RotorSport UK Ltd Service Bulletin (Permit)

Title: Improved IVO-prop motor		
SB No.: 098 Iss1	Related documents MC No: 276, 294, MC-323 CCAR No.: 064, 066	Compliance Category:
Applicability		OPTIONAL or RECOMMENDED or MANDATORY
Aircraft type & model: Calidus, Cavalon	Aircraft serial nos. affected: Any fitted with IVO-prop prior to 12.07.15	
This form is the response from RotorSport UK Ltd either against a problem found in the product in service requiring a containment or rectification action, or as service information for aircraft modification incorporation. For help, contact RotorSport on 44(0)1588 650769, or email info@rotorsport.org.		
<u>Reason and overview of the Service Bulletin (cause of problem if known)</u>		
IVO-prop DL3-68 in-flight variable pitch propellers are available as an option for Cavalon and Calidus recreational gyroplanes. The blade pitch of these propellers is changed by means of an electric motor/planetary gearbox/leadscrew driving a simple linkage in the root of each propeller blade. There are no electrical switches limiting blade movement because when the linkage reaches hard-stops in the propeller hub the motor current increases rapidly and is disconnecte

Motor/gearbox assembly removed

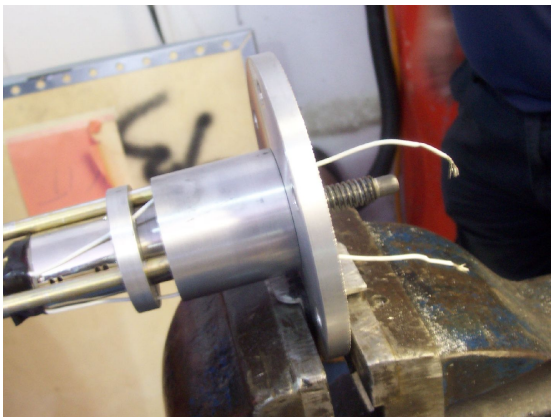
4. Transfer the propeller to a suitable work-bench and making reference to the propeller manual RSUK0325 remove the three blades then the motor/gearbox assembly.
(NB: Service Bulletins SB-083 Fit IVO-prop to Calidus and SB-088 Fit IVO-prop to Cavalon provide further information)

5. Using a 1/2"AF spanner progressively release the three nuts. Tap and pull the end cap then the sleeve off the protruding studs to expose the electric motor
